Sample Approval Form

Customer: Centra
Attention: Jagdeep Singh
CSR: Nicole Teplan
Die #: 16022
Description: (240 SERIES)
PD/SH/SS MEETING RAIL
Rigid Colour: WH-115
Flex Colour: N/A
Capstock Colour: N/A

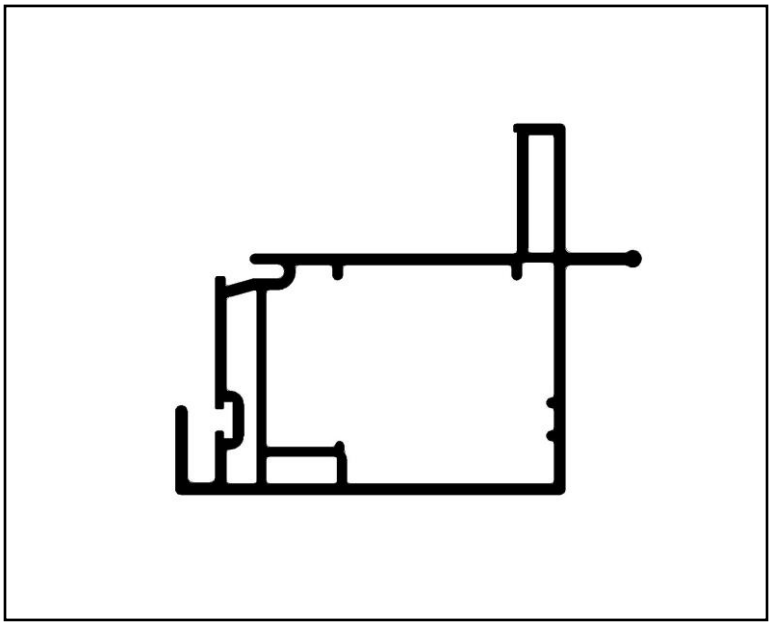
Comments: The die is approved with the dimensional tolerance per the manufacturing drrawing and a weight tolerance of ±10% based on 1.24g/cm3 for flex PVC and 1.46g/cm3 for rigid UPVC
